# Access Compliance Report

## Public Rights-of-Way

### (Curb Ramps)

Intersection ID: N/A	Main Street: INDEPENDENCE_BV	Cross Street: N/A	Location: SW
ADA ID: 8CDA36A9C7E6	Ramp Type: Perp	Initial Pass/Fail: Fail	Overall Compliance: No
			Severity Score: 13.75

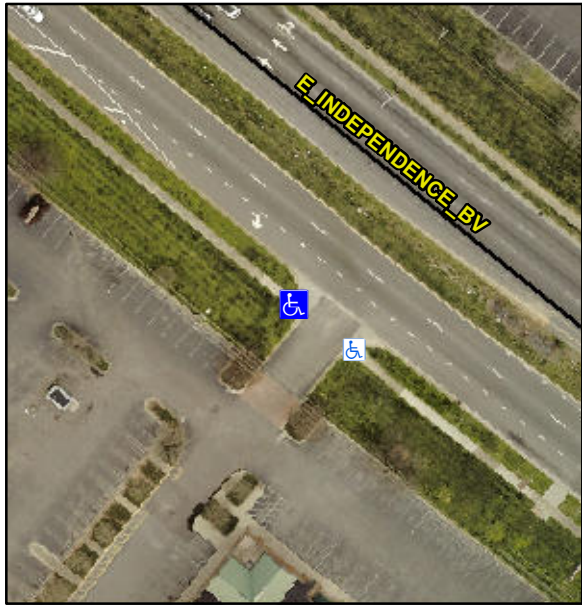
Codes/Mitigation Info/Possible Solution			Field Measurements/Component Compliance							
	Possible Solutions:		<b>Compliance</b>			<b>Description</b>			<b>Data</b>	
	<b>Remove &amp; Replace Entire Ramp.</b>		<b>N/A</b>	Ramp Length (in)	<b>79.5</b>	<b>No</b>	Ramp Slope (%)	<b>11.0</b>		
			<b>Yes</b>	Ramp Width (in)	<b>48.0</b>	<b>No</b>	Ramp XSlope (%)	<b>3.9</b>		
			<b>N/A</b>	Flare Type LT	<b>N/A</b>	<b>N/A</b>	Flare Type RT	<b>N/A</b>		
			<b>N/A</b>	Flare Slope LT (%)	<b>N/A</b>	<b>N/A</b>	Flare Slope RT (%)	<b>N/A</b>		
			<b>N/A</b>	Flare Traversable LT?	<b>N/A</b>	<b>N/A</b>	Flare Traversable RT?	<b>N/A</b>		
			<b>N/A</b>	Landing Length (in)	<b>N/A</b>	<b>N/A</b>	DWS Provided?	<b>N/A</b>		
			<b>N/A</b>	Landing Width (in)	<b>N/A</b>	<b>N/A</b>	DWS Contrast?	<b>N/A</b>		
			<b>N/A</b>	Landing Slope (%)	<b>N/A</b>	<b>N/A</b>	DWS Length (in)	<b>N/A</b>		
			<b>N/A</b>	Landing X Slope (%)	<b>N/A</b>	<b>N/A</b>	DWS Full Width?	<b>N/A</b>

Surveyor Notes:		<b>N/A</b>			<b>N/A</b>	Landing Curb? (Y/N)	<b>N/A</b>	<b>N/A</b>	DWS Offset (in)	<b>N/A</b>
PROW/ADA:		<b>Not Found, R304.2.2, R304.5.3</b>			<b>N/A</b>	Shared Landing?	<b>N/A</b>			
					<b>N/A</b>	Gutter Ponding?	<b>N/A</b>	<b>N/A</b>	Gutter Slope (%)	<b>N/A</b>
					<b>N/A</b>	Gutter Lip Ht (in)	<b>N/A</b>	<b>N/A</b>	Gutter X Slope (%)	<b>N/A</b>
					<b>N/A</b>	Painted X Walk1?	<b>No</b>	<b>N/A</b>	Painted X Walk2?	<b>N/A</b>
						X Walk 1 Direction	<b>To SE</b>		X Walk 2 Direction	<b>N/A</b>
					<b>N/A</b>	X Walk 1 Width (in)	<b>N/A</b>	<b>N/A</b>	X Walk 2 Width (in)	<b>N/A</b>
						X Walk 1 Slope (%)	<b>1.8</b>		X Walk 2 Slope (%)	<b>N/A</b>
						X Walk 1 X Slope (%)	<b>1.1</b>		X Walk 2 X Slope (%)	<b>N/A</b>
					<b>N/A</b>	Ramp inside XWalk1?	<b>N/A</b>	<b>N/A</b>	Ramp inside XWalk2?	<b>N/A</b>
						Road Slope (%)	<b>N/A</b>	<b>N/A</b>	Clear Space?	<b>N/A</b>
						Road X Slope (%)	<b>N/A</b>	<b>N/A</b>	Clear Space to XWalk (in)	<b>N/A</b>
